Application Number: 10/717,536 Filing Date: November 21, 2003 Appellant(s): HOLLIS ET AL.

EXAMINER'S ANSWER

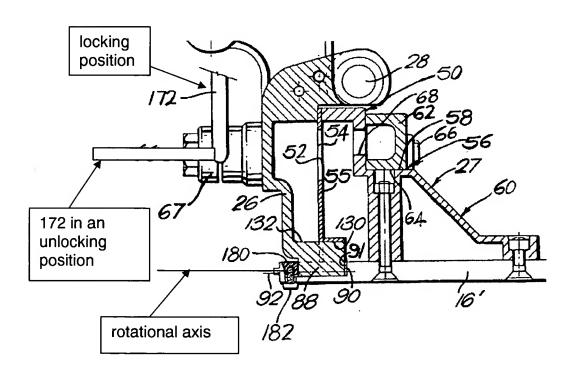
The examiner respectfully disagrees. According to Merriam-Webster Online

Dictionary (definition v. 6a.), "mounted" is defined as "to attach to a support". The element

172 is attached to the elements 66 wherein the element 66 joins the element 62 to the element 26

which is the saw support assembly. Hence, the bevel angle locking actuator 172 is indirectly

mounted to the saw support assembly 26. In addition, the term "translate" is defined as
